SUMMARY OF SUBMISSIONS

SUMMARY OF SUBMISSIONS TO PUBLIC EXHIBITION OF PLANNING PROPOSAL AND DRAFT DCP FOR 505-523 GEORGE SYDNEY

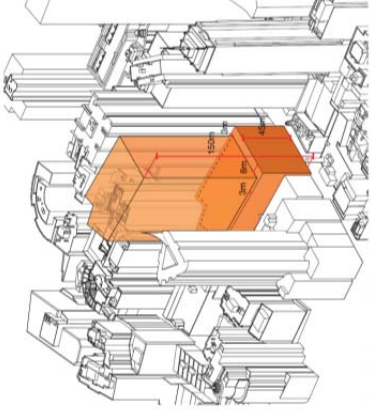
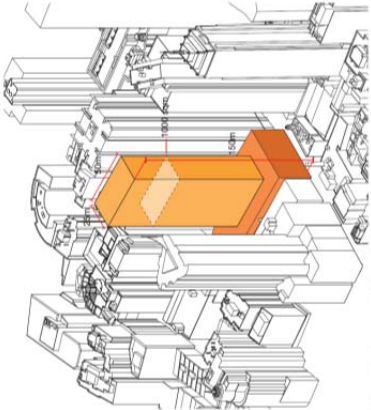
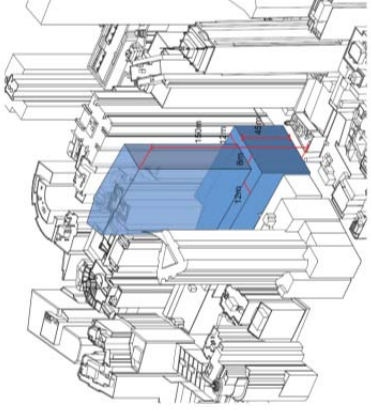
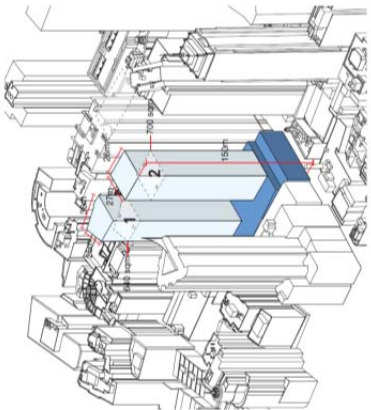
<p>SDCP2012 requires that a site specific DCP is to provide a site, context and development options analysis that documents and analyses at least three different and realistic site development options. No such options analysis was exhibited with the planning proposal/draft DCP</p>	<p>No changes recommended.</p> <p>A detailed urban design and architectural analysis of 505-523 George Street was exhibited with the planning proposal. This included a comparative analysis of a number of development options for 505-523 George St. The analysis took into account site characteristics, existing controls and context, including buildings within the vicinity of 505-523 George Street.</p> <p>The options included: a complying commercial scheme, a complying residential 'dual tower' scheme and the proposed scheme consisting of a single slender tower envelope. The latter option was found to be the best outcome for the site in terms of view impacts, amenity, sun access, tower crowding and overshadowing – both in relation to the AHL site and other sites in its vicinity. The investigations and analysis are considered to satisfy the provisions of the DCP.</p>
